SERVICE DIRECTIVE BULLETIN NO. 0107

DATE: November 7, 2008

1. SUBJECT: Wastegate Linkage Assembly
2. MODEL: F-28F, 280F, and 280FX
3. EFFECTIVITY: All
4. BACKGROUND:

Figure 1

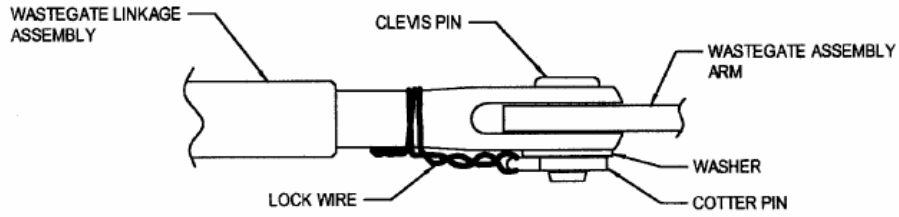
- F. Reinstall the wastegate linkage assembly. Install a lock wire (MS20995C32) through the eye of the cotter pin used to secure the clevis pin and washer at the linkage assembly and wastegate arm connection (Refer to Figure 1). Terminate the lock wire around the linkage assembly clevis. The lock wire prevents the clevis pin from rotating and extends the service life of the clevis pin, wastegate linkage assembly, and the wastegate.
- G. Insure the breakaway mechanism is engaged after installation.

Figure 3. New Wastegate Rod Assembly

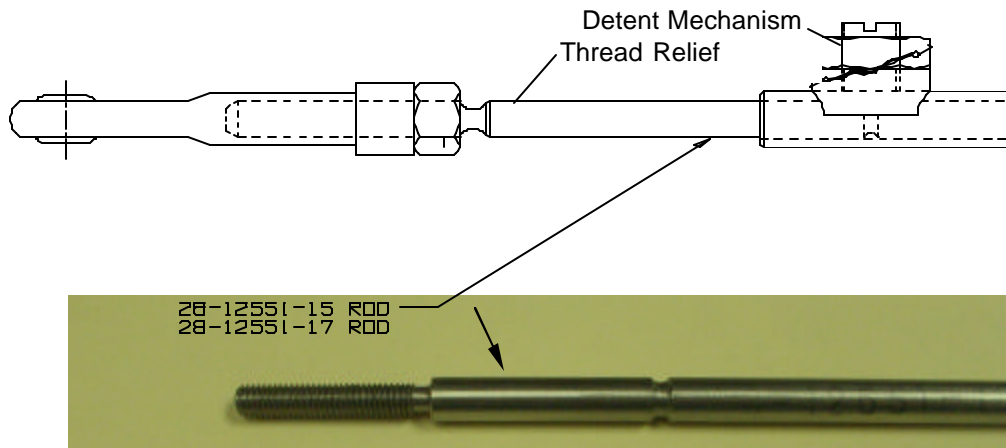
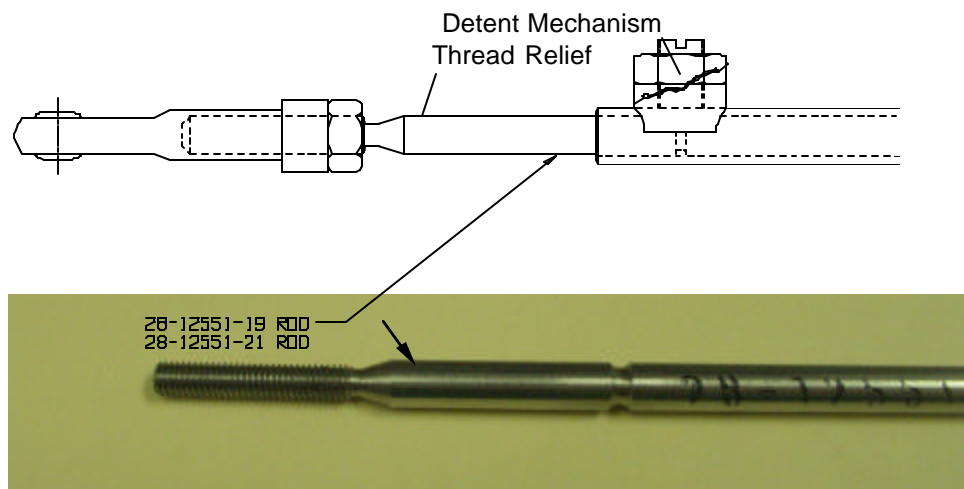
Enstrom received a field report of impaired throttle control due to the restrictor coming loose from the turbocharger bypass and jamming the wastegate. In the event of a jammed wastegate, the detent in the wastegate linkage is designed to break free and permit the linkage to telescope and allow the pilot to maintain throttle control. However, due to tolerance stack-up and the resulting wastegate rigging, after the linkage broke out of the detent, the detent locked into the thread relief near the end of the linkage rod and caused the throttle to lock in position. A change to the thread relief to prevent the detent from locking into the thread relief has been incorporated into the wastegate linkage assembly.

While no further action is required, Enstrom strongly recommends modifying or replacing the P/N 28-12551-15/-17 rod with a P/N 28-12551-19/-21 to eliminate any potential interference in the future.

- A. Disassemble the wastegate linkage assembly. To modify the existing rod, proceed to Step B. To replace the rod, proceed to Step C.
- B. Modify the existing rod in accordance with Figure 5 and proceed to Step D.
 - (1) Use a manual or CNC lathe.
 - (2) Turn a 0.16" by 20° chamfer as shown.
 - (3) Turn a 0.02" by 45° chamfer as shown. Break sharp corners.
 - (4) Minimum 63 surface finish required.
- C. Determine whether to install P/N 28-12551-19 or P/N 28-12551-21 by measuring the section of the old rod at the location shown in Figure 4. For 2.74", install the -21 rod. For 2.36", install the -19 rod.
- D. Reassemble the wastegate linkage assembly with the modified or new rod (Figure 2). Do not overtorque the spring plunger nut. Torque the nut 12-15 in-lbs/1.4-1.7 N-m.
